Application No. SDP16-00006 (Site Development Permit)

STAFF REPORT

Project name: Inneswood Apartments

Request: Site Development Permit **approval** for 2 multi-family buildings with a total of 93 units on approx. 5.72 acres. The site includes approximately 2.41 acres of critical areas in a separate tract (Tract B), reducing the developable area to 3.31 acres. Site access is on Newport Way. Resident parking in a two-level garage and on-street visitor parking provided. Frontage improvements include a City-planned roundabout at the intersection of Newport Way NW and NW Juniper St. (See Site Plan, sheet C1.06).

Fig. 5. Roundabout and Detention Vault with landscape proposed

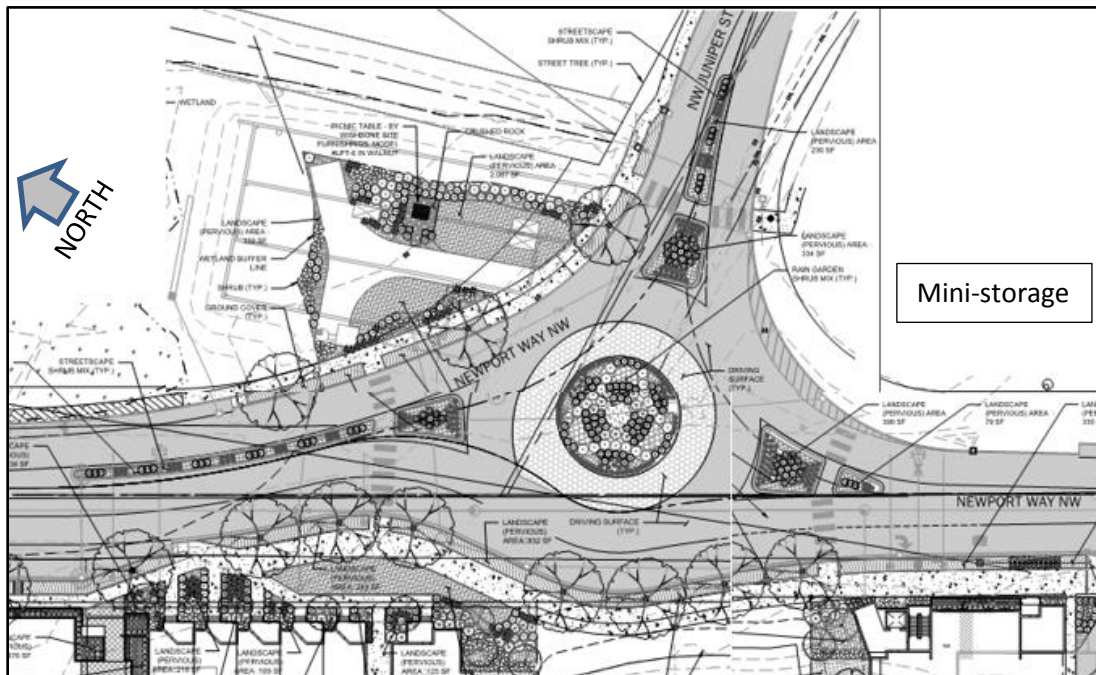
The design of the roundabout was based on the City's 30% construction drawings. The City's Public Works Engineering staff has provided input in the design of the roundabout and a third party consultant familiar with the CIDDS was used during the review of the proposed design. Review of the roundabout to date focused on the application of design principles for Circulation Facilities found in the CIDDS, including pedestrian-friendly features, intuitive wayfinding and reduction of pavement. The proposed landscaping and location of crosswalks is acceptable at this level of review.

The roundabout is designed with pedestrian refuges where crosswalks are provided. The refuges are proposed to be landscaped. The roundabout center space will be provided with a driving pad to accommodate wider turns of fire trucks and maintenance vehicles. This area will be provided with special paving so that it reads as part of the central landscaped planter area.

Pedestrian crosswalks will be provided as part of the roundabout (see Fig. 5. Roundabout and Detention Vault with landscape proposed). Across from the Inneswood property, a boardwalk will be provided at the Abossein property to provide pedestrian connection through the wetland buffer and connect to the existing walkway on the King County Library property. At the southeast corner, where a mini-storage building is located, the sidewalks are at-grade asphalt and delineated with a fog line along the east side of Newport Way. There is an existing swale running along the corner of the mini-storage property (see Fig. 7, Existing walkways and future sidewalk for mini-storage site). There is an existing wide walkway running east-west from the crosswalk at Newport Way to the facility that is further setback from Juniper and avoids the swale at the north side of the property.

Fig. 6. Public and Private Pedestrian zones

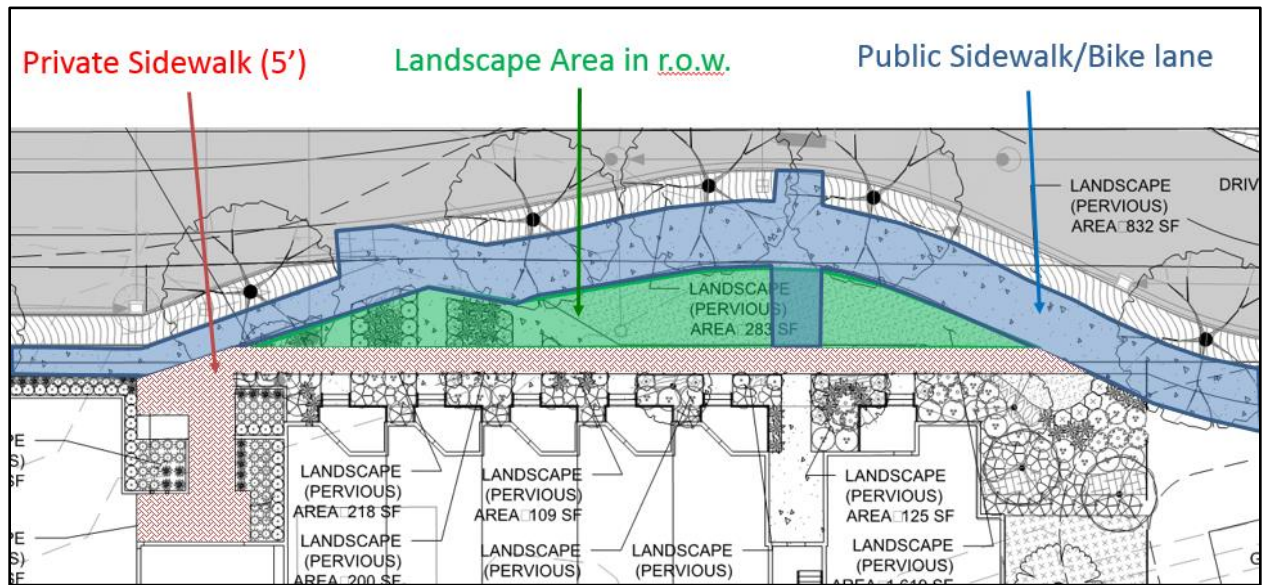
The proposed walkways in front of the townhouses at the northern half of the large building are shown to extend into the right-of-way and connect to the wider multi-use trail that runs parallel to Newport Way. The landscape yards of the townhouses also extend out into the right-of-way. There should be a clear delineation of the private yard from the public right-of-way where public access is allowed. The proposed landscape design privatizes the landscape area of the right-of-way. The sidewalk and planter area can be reconfigured to better define the public zone and private zone by introducing a separate private walkway to serve the residential entries, with special paving that is coordinated with the design of the residential porches and landscape yards (See Fig. 6. Public and Private Pedestrian zones).

[Condition 7] ***Redesign the walkways and front yards of the townhouses, as illustrated in the staff report. The landscape scheme of the right-of-way shall read as part of the Newport Way "greenway". The "private zone" shall be differentiated from the "public zone" by providing a 5-foot wide private walkway with special paving as the boundary for the two zones.***

Fig. 9. Proposed community space for the Abossein Parcel

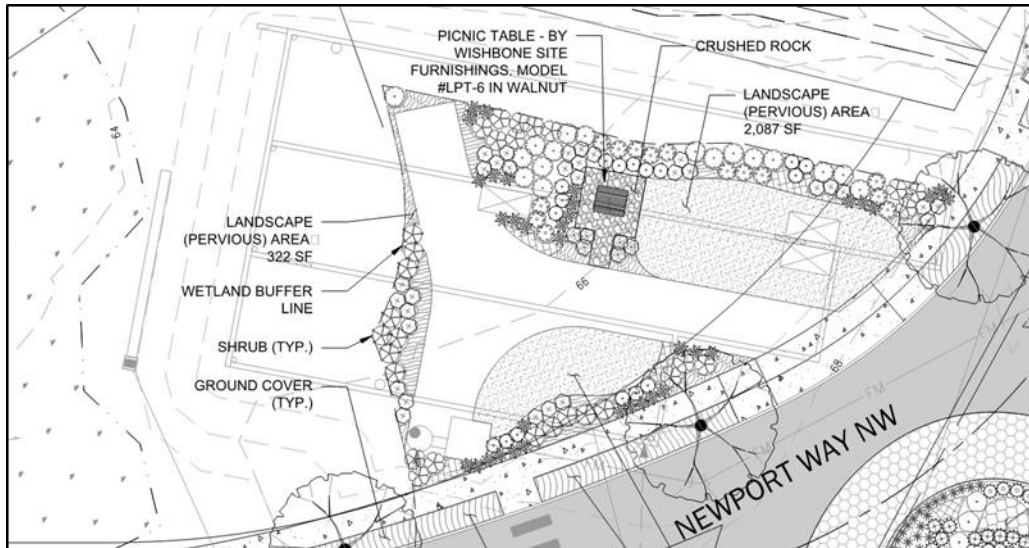
The Abossein parcel integrates a stormwater detention vault and the wetland buffer with recreational space (see Fig. 9, Proposed community space for the Abossein Parcel). However, the paved area has a distinct edge contrary to CIDDS 13.2.B.2.b. The revised configuration (see Fig. 10, Redesign Community Space in the Abossein Parcel) illustrates how the space can be used for many things, and masks the presence of the vault maintenance access with the plaza paving, thus integrating it into community space elements.

[Condition 14] ***The Abossein open space shall be designed so that the maintenance vehicle driveway is integrated into a plaza designed as an activity area with a wetland overlook, such as illustrated in the Staff Report Figure 10.***

Fig. 16. 7-unit Building Build-to-Line

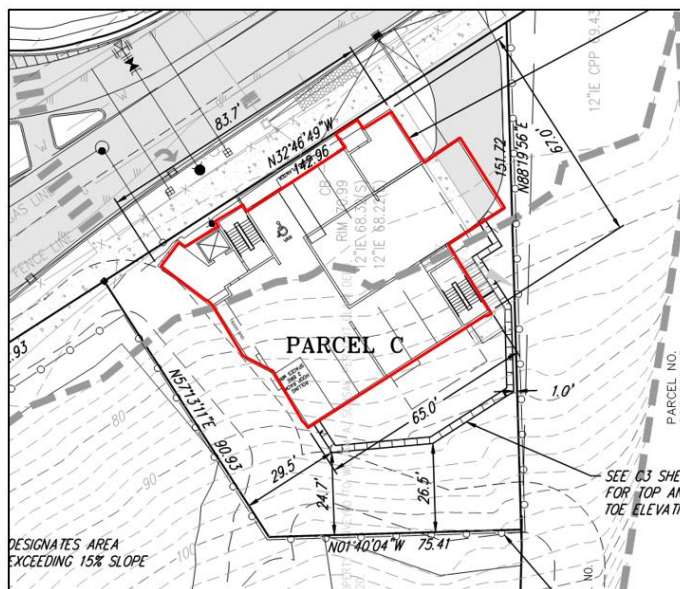
For the 86-unit building, the townhouse porches are recessed and planters are used in a rhythmic sequence to create the build-to-line variation. The center of the building is also broken up by the plaza and main building entry canopy. The plaza creates the “void” that provides relief from the line of townhouses (see sheet L2.01). For the 7-unit building, the building entry is off-set at an angle from the property line. The corners of the building are extended close to the sidewalk while the middle section is recessed where the garage wall is located (see Fig. 16, red outline shows modulation at Build-to-Line of 7-unit building).

Parcel B (86-unit building) has a street frontage length of 437.83 ft. The portion of the building that is at the build-to-line is approx. 300 ft. or 68.5% of the lot frontage. Parcel C (7-unit building) has a lot frontage length of approx. 143 ft. The portion of the building at the build-to-line is 83.7 ft. or 58.5%. The minimum length of the building that is required to be at the build to line, at 60%, is approx. 85.8 ft.

[Condition 21] ***Additional building or vertical element along the street frontage of the 7-unit shall be provided using options identified in CIDDs 11.3.I or 11.3.J.***

Fig.22. Examples of small gathering spaces

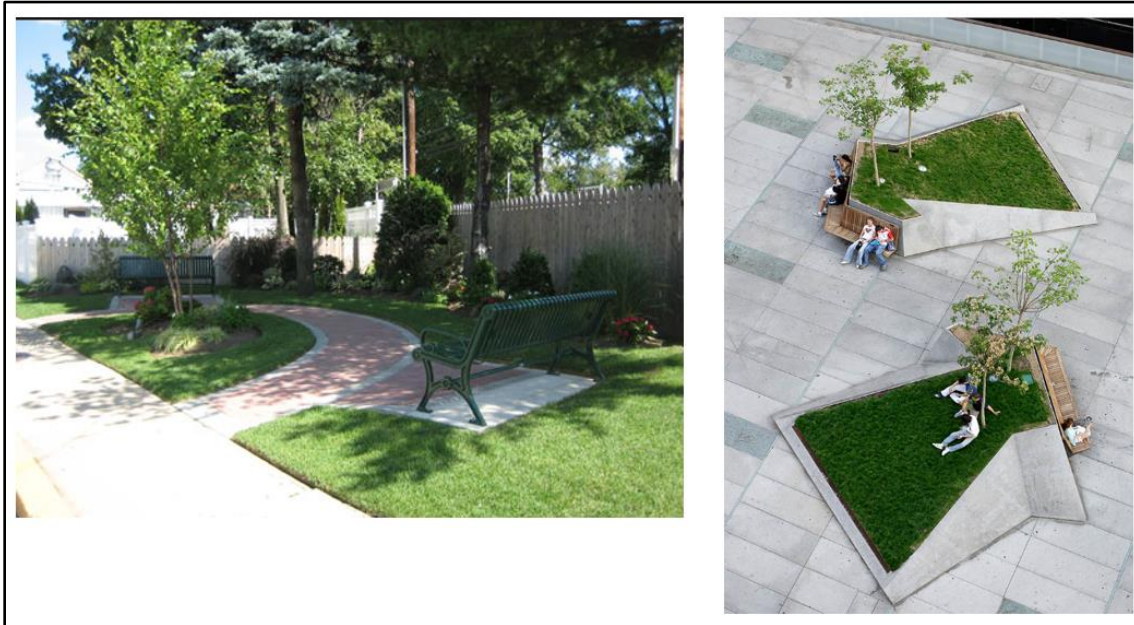
To further assist the Development Commission and the Applicant to visualize the possibilities for this space, the examples in Fig. 22, Examples of small gathering spaces, are provided. These spaces used common landscape elements creatively to make the gathering space inviting, including:

- Special paving (scored concrete sidewalks is fine, as long as it looks like landscape plaza paving)
- Seating, integrated to the planters or stand alone
- Geometric forms distinguishes the people spaces from the natural features but are well- integrated with planted areas
- Planters designed creatively so they become part of the “specialness” of the space

[Condition 23] ***The green space in the right-of-way that is currently treated as an oversized planter area shall be designed as an informal gathering space and provided with special paving and landscape planter areas similar to the outdoor plaza in Juanita Village included in the CIDDS as an example of good plaza design.***
